AGENDA PORTLAND PLANNING BOARD MEETING

To: Brandon Mazer, Chair and Members of the Portland Planning Board
From: Caitlin Cameron, Urban Designer
Date: Friday, September 18, 2020
Re: Rezone from R6 to B3 and Text Amendment; 148 State Street; City of Portland
Project #: ZN-001163-2020
CBL: 045 C006001, 045 C7001, 045 C1001
Meeting Date: September 22, 2020

Gabriel Zappia is requesting a workshop for a Level III Site Plan and Subdivision application at 1844 Forest Avenue. The applicant is proposing seventeen (17) residential apartments with the intent to lease the units. They are proposing to convert the existing dance and karate studio to a residential use. The proposed reconfiguration of the units will occur wholly within the existing structure, with minimal proposed changes to the building exterior. The parcel is located in the B-2 Community Business Zone.

Figure 7 Map Amendment Option 1 (R-6 to B-3 on State and Winter streets)

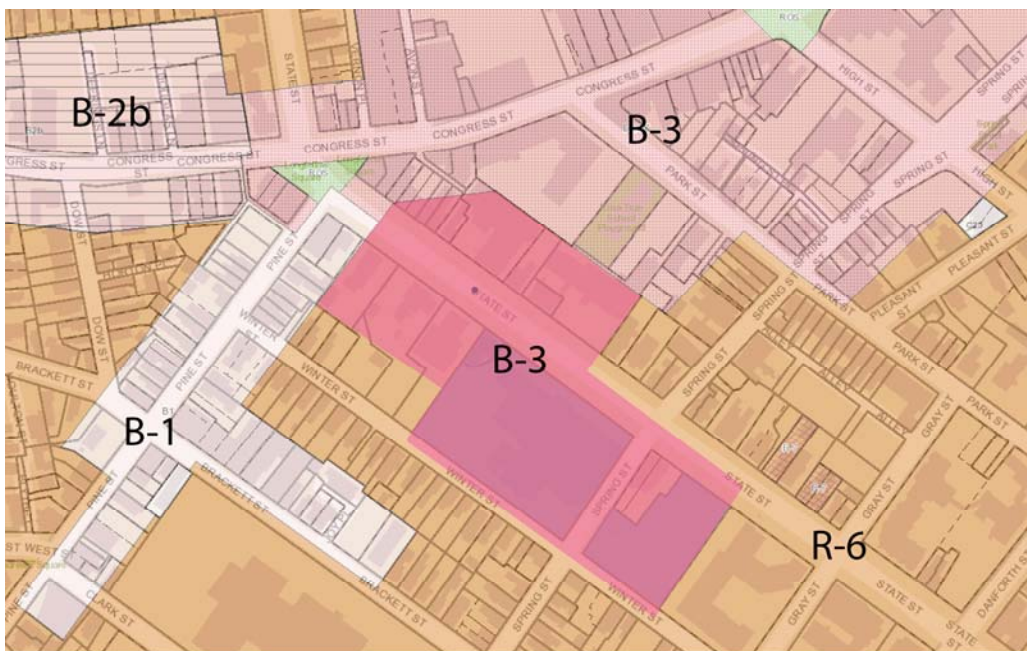
Along with the applicant's parcels, Planning is recommending that the Planning Board consider extending the B-3 zone to connect to the existing B-3 zone on Congress Street, extending to include properties on both sides of State Street (in the R-6). The B-3 zone would then encompass existing properties that are also legally non-conforming to R-6 in scale, dimensional standards and/or use, meaning the B-3 zoning would better reflect the on-the-ground conditions of these few parcels and create a contiguous B-3 zone. B-3 is also a zone that exists across a contiguous area of Portland's downtown, rather than in isolated pockets or nodes, and this extension would be consistent with the current application and purpose of the zone. The proposal would limit the extent of the B-3 on Winter Street to only the applicant's proposal to keep to a minimum the use and scale impacts on the residential street.

Though staff finds that generally the B-3 zone for the applicant's property, and potentially for an expanded, contiguous area, is a zone amendment that would support redevelopment of this important area, and also allow for the redevelopment of existing, nonconforming aspects of the property, staff recognizes that the B-3 introduces a significant new range of scale and uses on the Winter Street side of the proposal. Though the current pattern of the Mercy property on the Winter Street side has long not been of the same pattern as the residential facing side, redevelopment of this side of the street will need to be designed for compatibility with the surrounding context. The Historic Preservation Board review that will be required, as well as the 45 height limit in the applicant's proposal, will help guide contextually sensitive redevelopment of Winter Street. B-3 is still more intensive than the existing zoning both dimensionally and in terms of permitted uses, which in the B-3 include medical marijuana facilities, restaurants, drinking establishments, office space, hotels, and a plethora of others). Although the applicant's indication of what uses are planned there in a future development includes only residential uses on Winter Street, there exists the possibility of some of these uses being introduced adjacent to quiet, residential properties. Consideration of Winter Street impacts, either within the proposed B-3, or another zoning alternative, is a central consideration of review of this proposal.

Figure 8 Map Amendment Option 2 (R-6 to B-3 on State St and R-7 on Winter St)

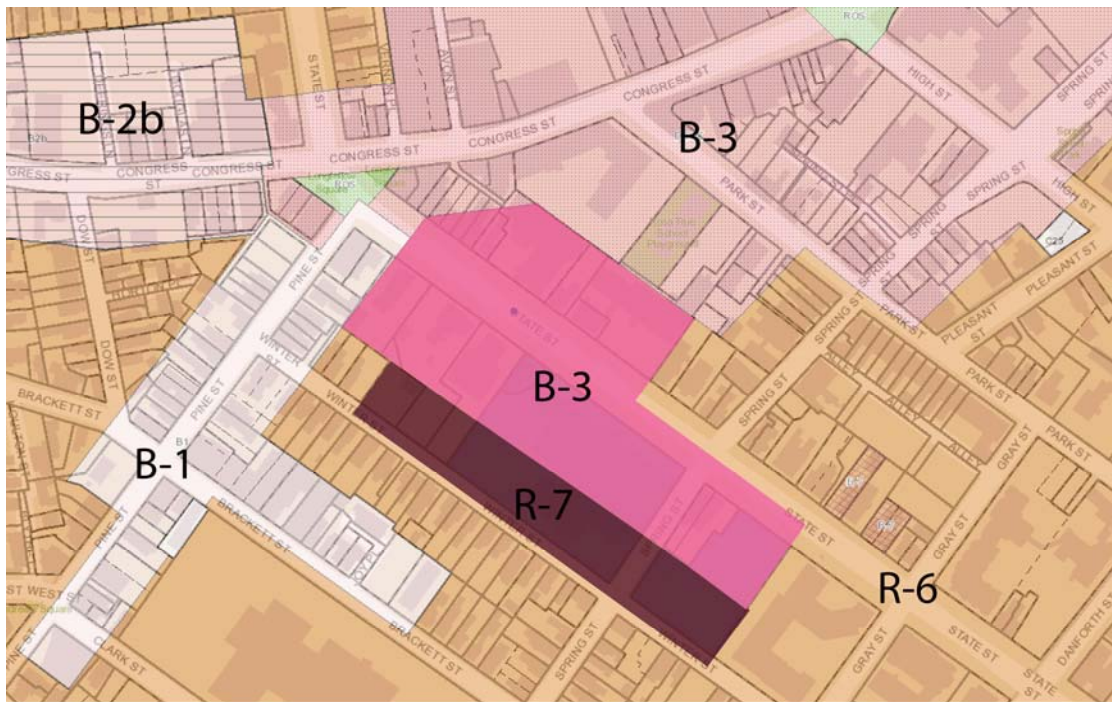
Planning also discussed an alternative option that places a residential zone on Winter Street. In this Option 2, R-7 is contemplated for the majority of the Winter Street frontage. Staff see several advantages to this approach:

- Uses: The predominantly residential uses of the R-6 would be preserved on Winter Street, keeping a more compatible use table within this streetscape. The applicant does not intend to place commercial/mixed-uses on Winter Street, this proposal would not interfere with the anticipated development program.
- Scale: The R-7 dimensional standards are similar to the more permissive B-3 zone (lot coverage, setbacks), allows for up to 50' in building height (higher than the proposed maximum in the B-3), but does not include the more restrictive dimensional standards of the R-6 such as stepbacks, garage door dimensions. Neither the R-6 or R-7 limits building length.
- Density: R-7 as a higher density allowance than the R-6 to accommodate the applicant's goals.
- Parking: The R-7 (and R-6) does not have the 35' setback limitation on surface parking, providing more flexibility for parking design.

The primary benefit of the introduction of the R-7 zone would be to limit non-residential uses and non-residential buildings along Winter Street. The introduction of the R-7 would be somewhat more intensive than the existing zone, but would allow for residential redevelopment that transitions from the taller, mixed-use redevelopment along State Street into the R-6 neighborhood at the rear. This alternative would include a splitting of the existing parcels with a zone line, and would require further evaluation as to precisely where this would fall to ensure a seamless redevelopment of the properties. If the Planning Board were interested in further evaluation of the R-7, staff would include additional R-7 analysis in materials for a future workshop.
